Subject: Duke Energy Carolinas, LLC.  
William States Lee III Nuclear Station - Docket Nos. 52-018 and 52-019  
AP1000 Combined License Application for the William States Lee III  
Nuclear Station Units 1 and 2  
Partial Response to Request for Additional Information (RAI No. 919)  
Ltr # WLG2008.11-29

**Lee Nuclear Station Response to Request for Additional Information (RAI)**

**RAI Letter No. 030**

**Reference NRC RAI Number(s): 13.01.01-008**

**WILLIAM STATES LEE III**  
**NUCLEAR STATION UNITS 1 & 2**  
Duke Energy Corporate  
FIGURE 13.1-204 Rev 1

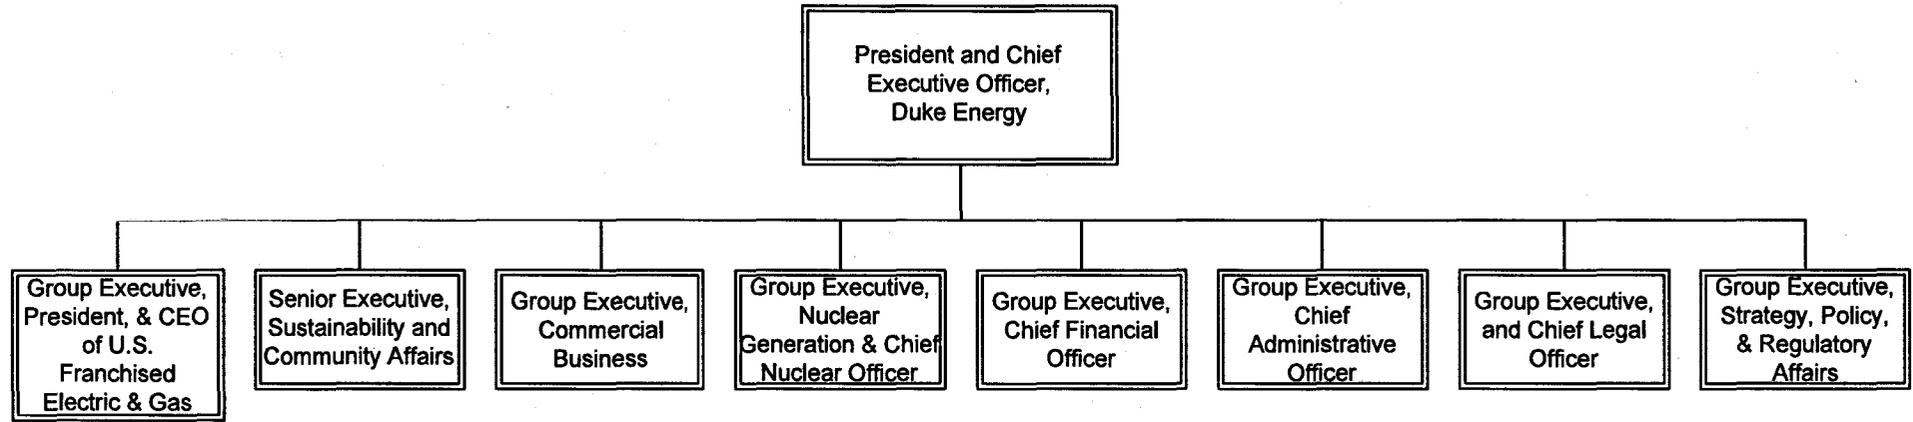
Standard Review Plan Section 13.1.1, "Management and Technical Support Organization," section I.2.B and RG 1.206, section C.I.13.1.1.2, "Organizational Arrangement", request the applicant to provide the relationship of the nuclear-oriented part of the organization to the rest of the corporate organization.

Either identify where this information is in the application, provide the information, or justify why it is not needed.

Information regarding how the nuclear-oriented part of the organization relates to the rest of the corporate organization will be provided in new FSAR Figure 13.1-204. Figure 13.1-204 contains the Duke Energy corporate organization chart which shows the relationship between the Chief Nuclear Officer (i.e., nuclear-oriented part of the organization) and the rest of corporate organization. FSAR Figure 13.1-203 shows the executive organization that reports to the Chief Nuclear Operation.

**Addition of FSAR Chapter 13, Figure 13.1-204**
